M645 SUPER

7 TECHNICAL BULLETIN

NEW CONTACTS FOR CONNECTOR N

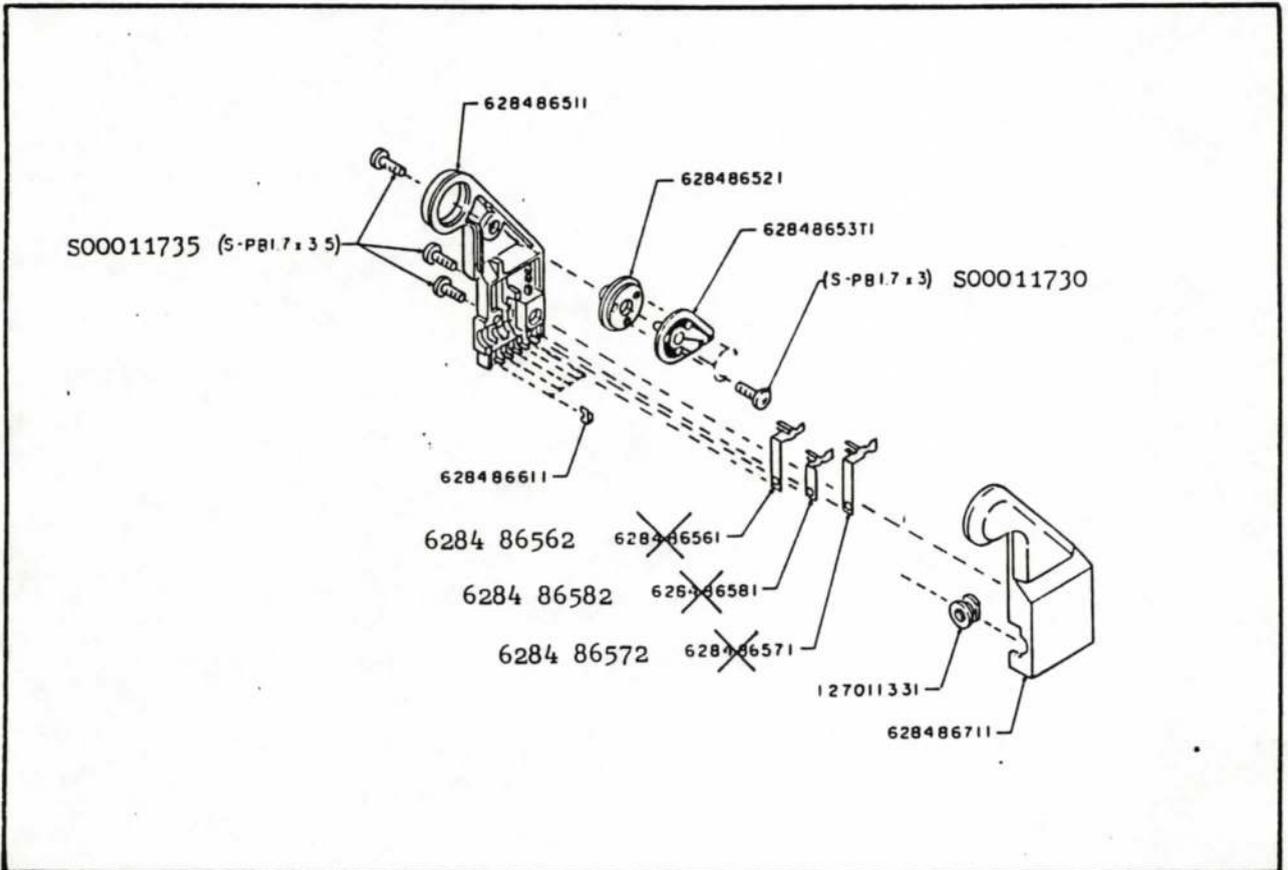
- 1. CAUSE : Contact B,C, and D : Weakened.
- 2. MODIFICATION : Material of contact B,C, and D : Changed.
- 3. MODIFICATION DATE : Since 1987 March production.

New P/No. 6284 86562 Contact D
 6284 86582 Contact B
 6284 86572 Contact C

NEW RELEASE PLATE FOR AUTO BELLOWS

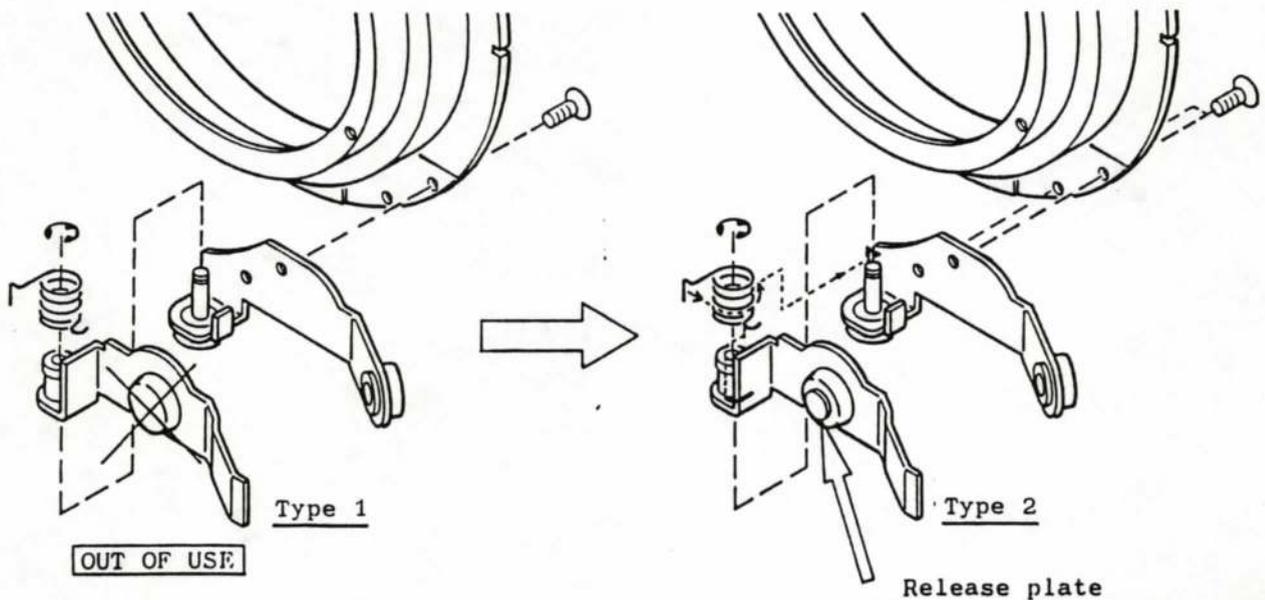
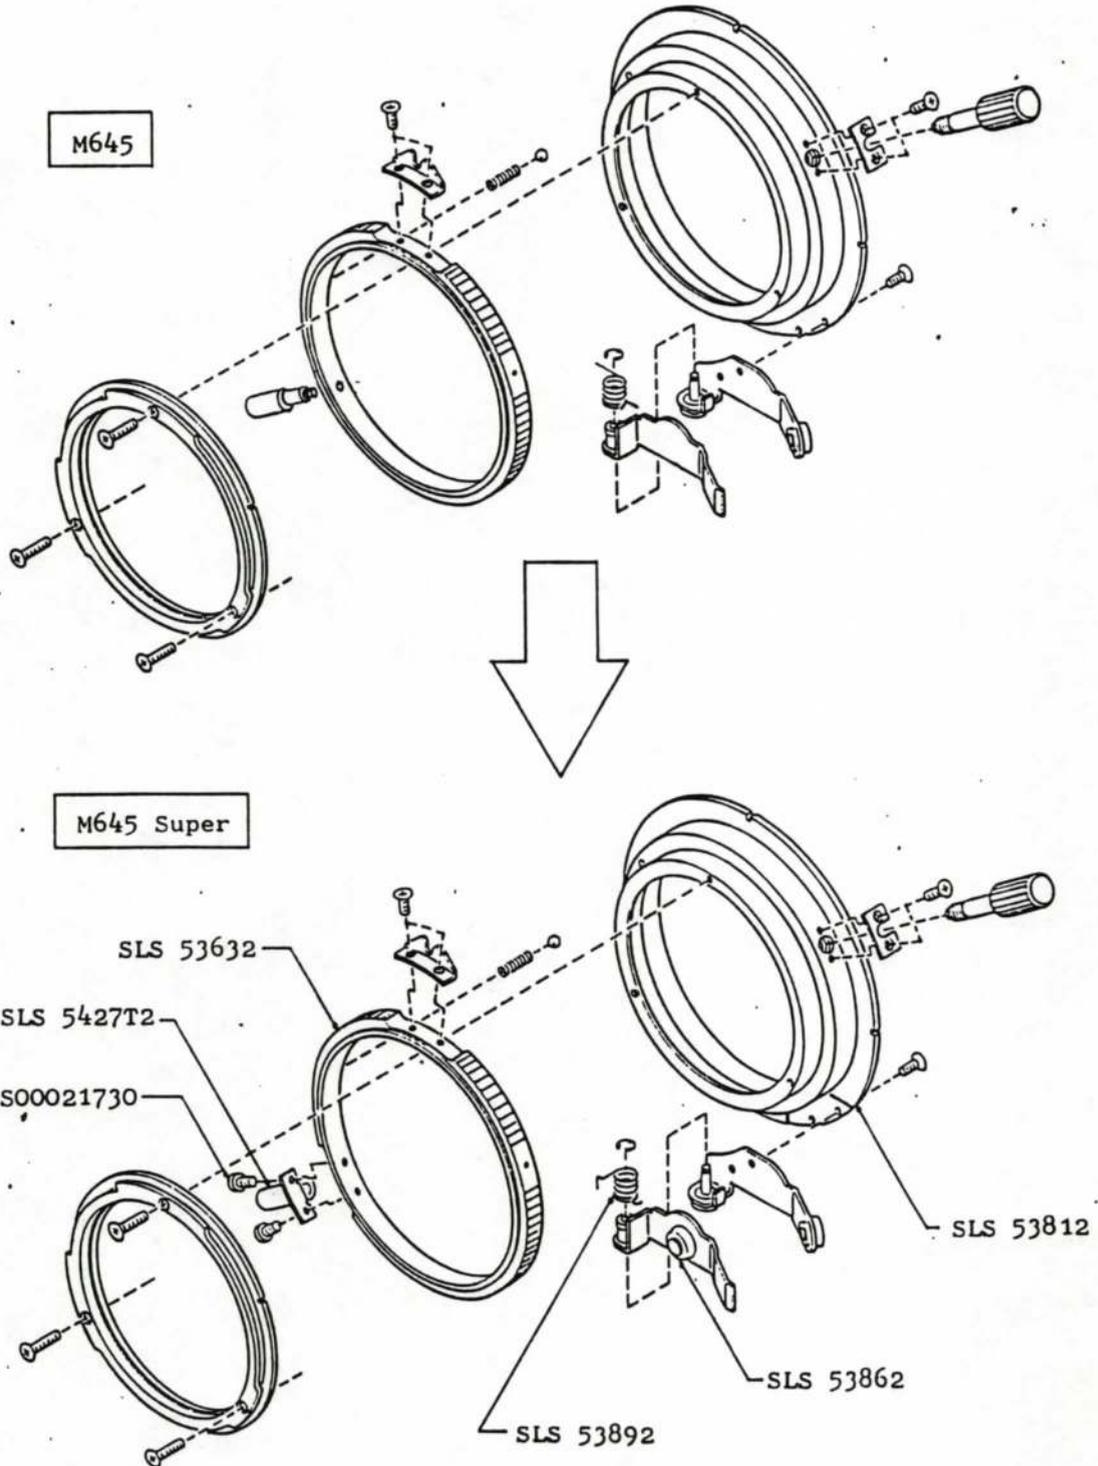
1. CAUSE : Release plate(type 1) does not push the release button of body.

2. MODIFICATION : Shape of release plate.

3. MODIFICATION DATE : From October, 1986.

4. REPAIR STEP : Replacement of release plate (type 2)
